VDD
J2A
J2B
J2C
J2D
J2E
RED or GREEN indicates selected mode
RN7
RN8P4R
D1 LED
D2 LED
D3 LED
U33
ULN2803A
U1
U5
U8
U12
U16
U18
U22
U24
DS90LV47A
U37
BDG1A
PECL used to drive ROD_CLK
originally had LVDS driver
CHIP is deadbugged
U35
EPF6016AQC208
U36
EPC1PC8
J4
BYTE BLASTER
U26
CYB993V
U27
40MHZ
U28
SY10ELTV20V
may not require
differential signalling
U30
U31
U34
CY7B991V
U4
U7
U11
U13
U17
U23
U25
U29
U32
DS90LV048
R1
R2
R3
R4
R5
R7
R8
R9
R10
R11
R13
R14
R15
R17
R19
R20
R21
R22
R23
R24
R25
R26
R27
R28
R29
R31
R32
R33
R34
R35
R36
R37
R43
R44
R46
R47
R48
R49
R50
level translation
TP17
TP18
TP1
TP2
TP3
TP4
TP5
TP6
TP7
TP8
TP9
TP10
TP15
TP16
J14
CONN-DSUB-37
J8
J7
J3
Optional hookup
This connector always has a cable
signal is long due to rework
Sivasubramaniyan / Virzi
Schematic of Back of Crate Card
Size D
Document Number
<Doc>
Rev
<RevCode>
Date: Tuesday, July 15, 2003

Sheet 1 of 1

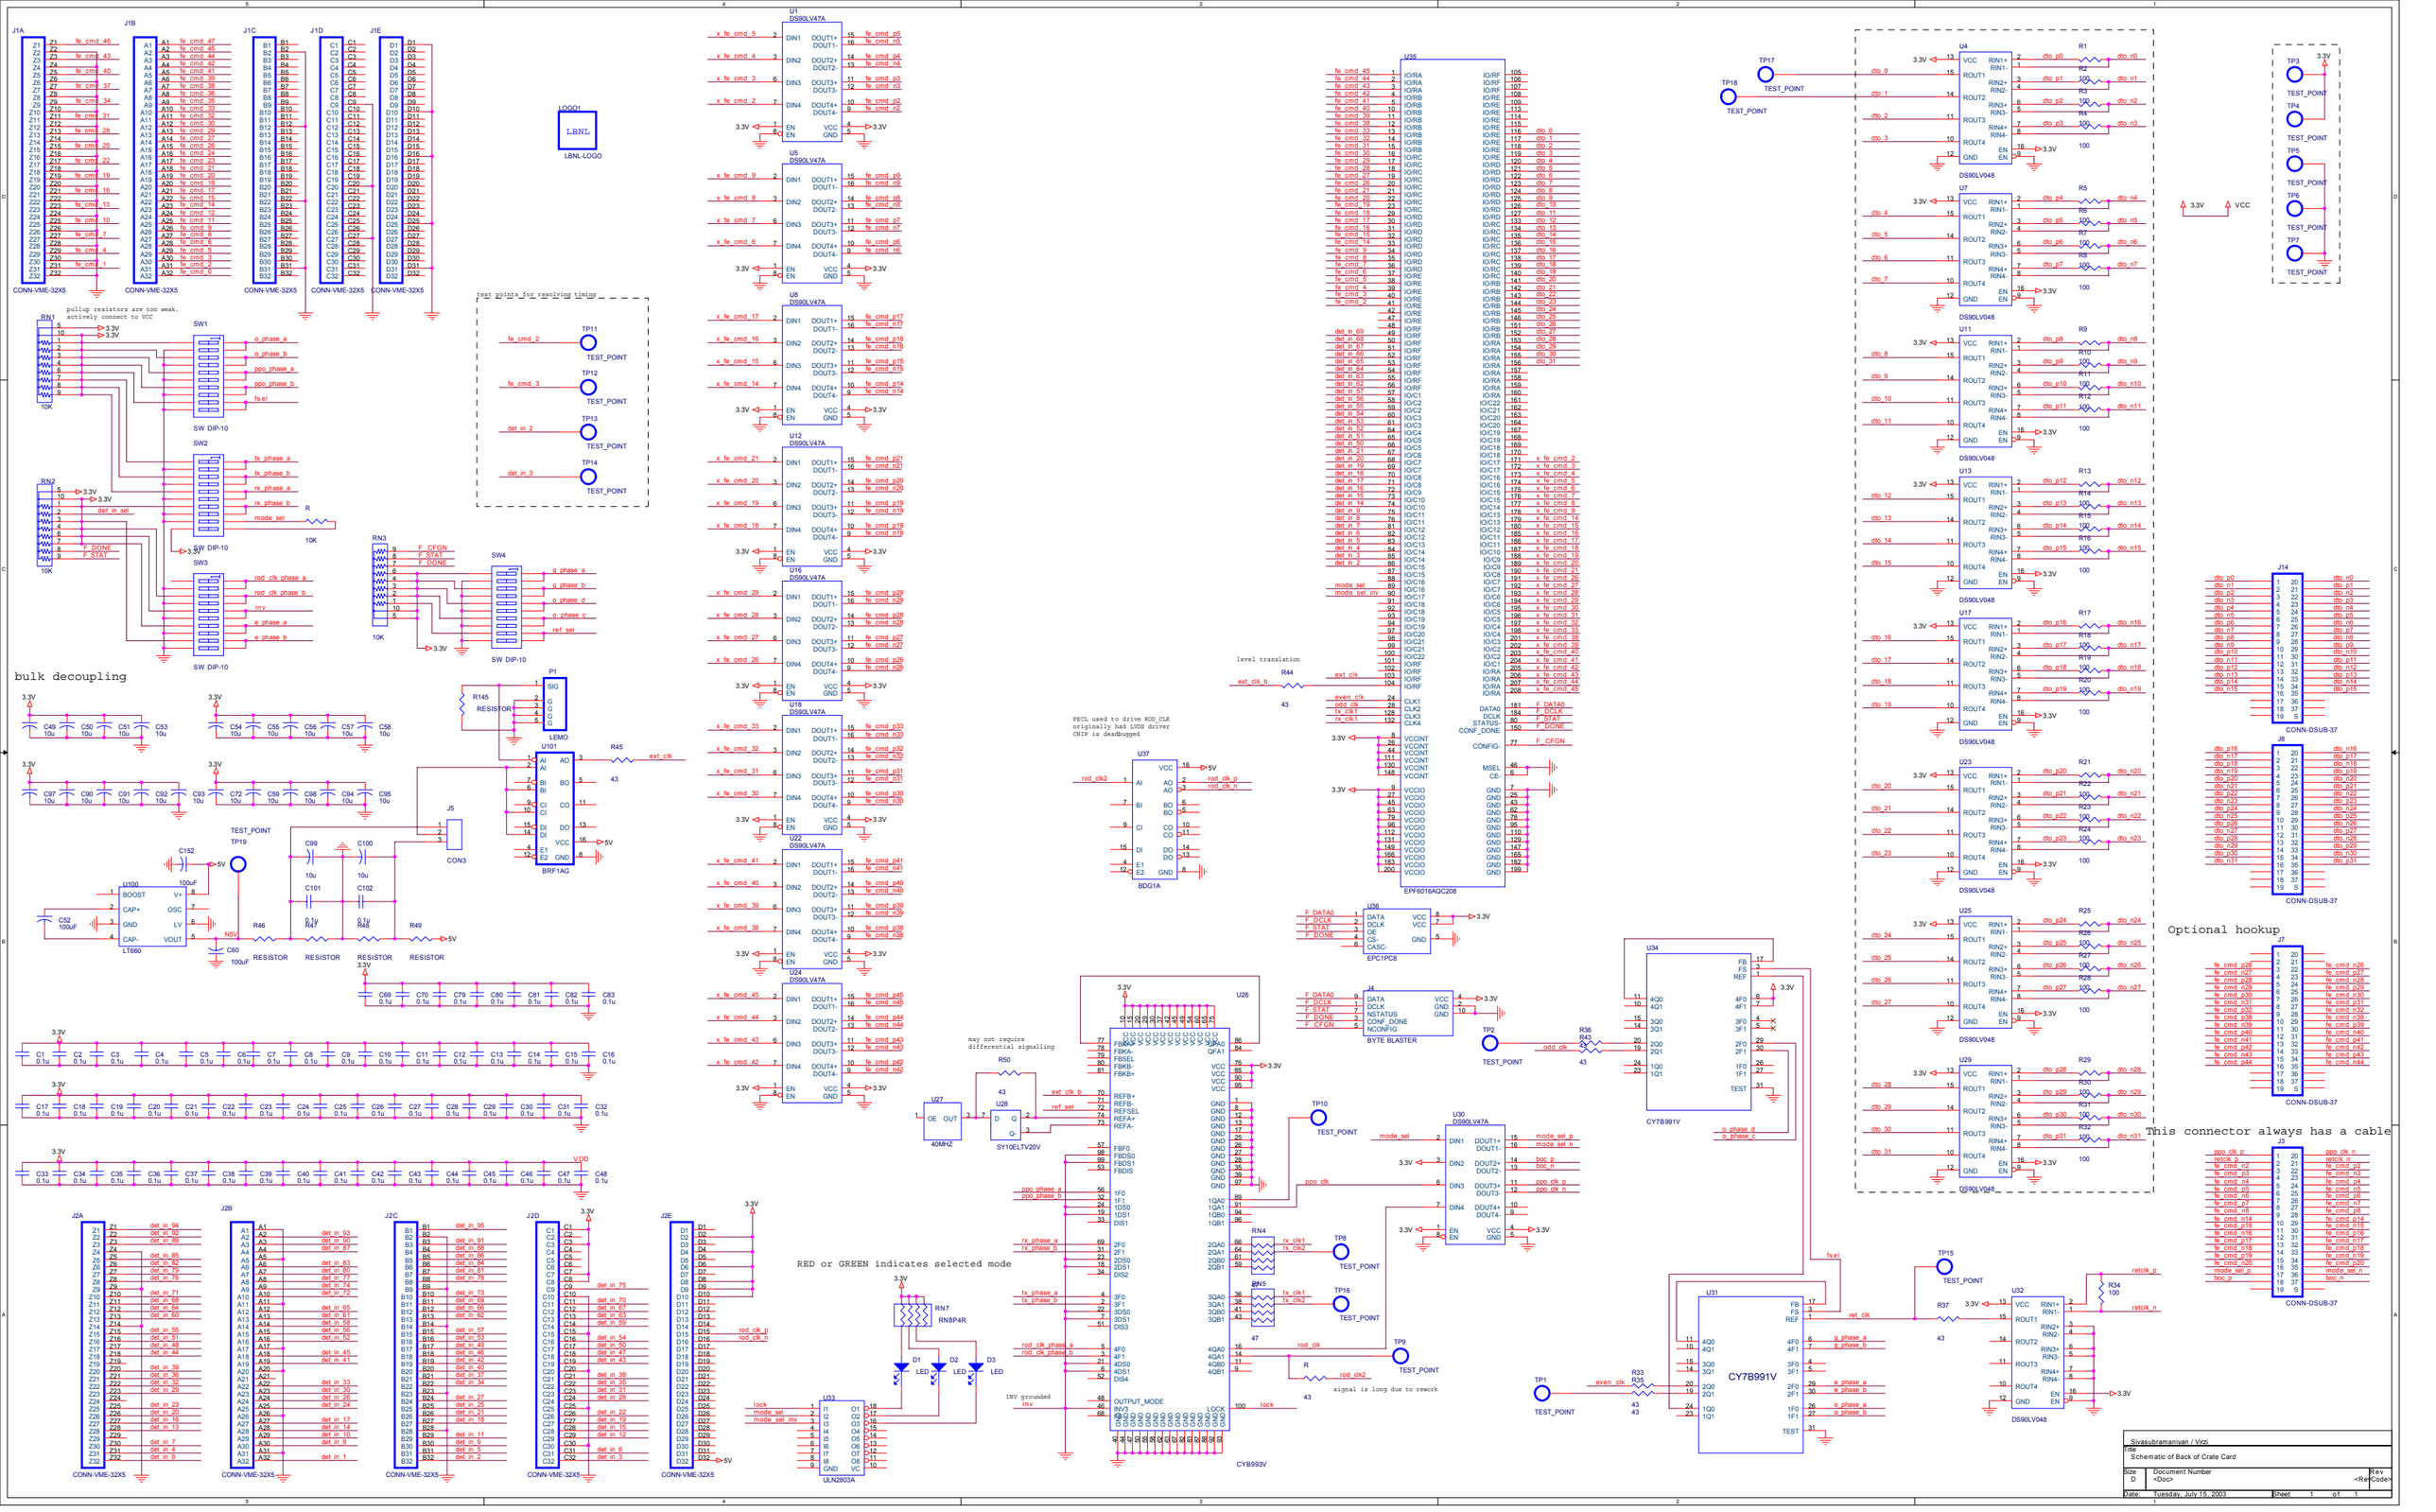
J1A
J1B
J1C
J1D
J1E
CONN-VME-32X5
LOGO1
LBNL
LBNL-LOGO
pullup resistors are too weak.
actively connect to VCC
RN1
RN2
RN3
SW1
SW2
SW3
SW4
SW DIP-10
10K
R
bulk decoupling
C49 10u
C50 10u
C51 10u
C53 10u
C54 10u
C55 10u
C56 10u
C57 10u
C58 10u
C97 10u
C90 10u
C91 10u
C92 10u
C93 10u
C72 10u
C59 10u
C98 10u
C94 10u
C95 10u
test points for resolving timing
TP11
TP12
TP13
TP14
TEST_POINT
LEMO
P1
R145
RESISTOR
U101
R45
ext_clk
J5
CON3
TP19
C152
100uF
U100
LT660
C52 100uF
C60 100uF
C99 10u
C100 10u
C101 0.1u
C102 0.1u
C47 0.1u
C48 0.1u
R46
R47
R48
R49
BRF1AG
C69 0.1u
C70 0.1u
C79 0.1u
C80 0.1u
C81 0.1u
C82 0.1u
C83 0.1u
C1 0.1u
C2 0.1u
C3 0.1u
C4 0.1u
C5 0.1u
C6 0.1u
C7 0.1u
C8 0.1u
C9 0.1u
C10 0.1u
C11 0.1u
C12 0.1u
C13 0.1u
C14 0.1u
C15 0.1u
C16 0.1u
C17 0.1u
C18 0.1u
C19 0.1u
C20 0.1u
C21 0.1u
C22 0.1u
C23 0.1u
C24 0.1u
C25 0.1u
C26 0.1u
C27 0.1u
C28 0.1u
C29 0.1u
C30 0.1u
C31 0.1u
C32 0.1u
C33 0.1u
C34 0.1u
C35 0.1u
C36 0.1u
C37 0.1u
C38 0.1u
C39 0.1u
C40 0.1u
C41 0.1u
C42 0.1u
C43 0.1u
C44 0.1u
C45 0.1u
C46 0.1u
